April 20, 2017

RE: INSPECTION: PERMIT 330 -- LAKE FAYETTEVILLE - WASHINGTON CO.

Figures 1 & 2. Large trees growing on upstream slope. Cracks forming on crest of dam caused by root systems of large trees.

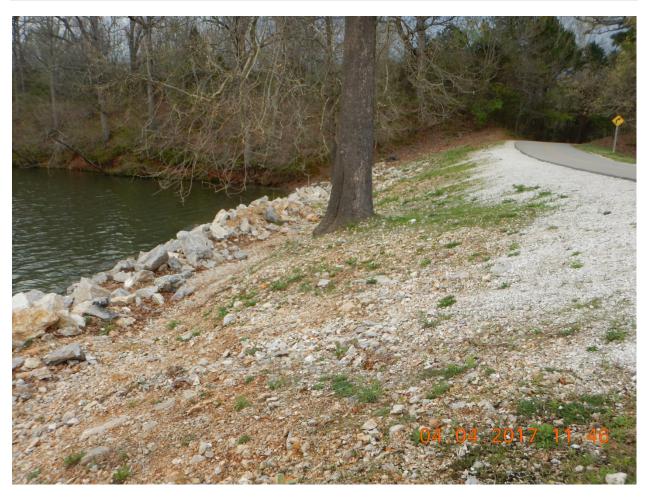
The upstream slope of the dam and the crest appeared to be in good condition overall. There are large trees growing on the upstream slope, and their root systems are causing small depressions and small cracks to form on the crest of the dam (Figure 1 & 2). The rip-rap added along the shoreline appears to be holding its position, but the rip-rap line could be brought further up the slope to help prevent erosion when the lake is higher (**Figure 3**).
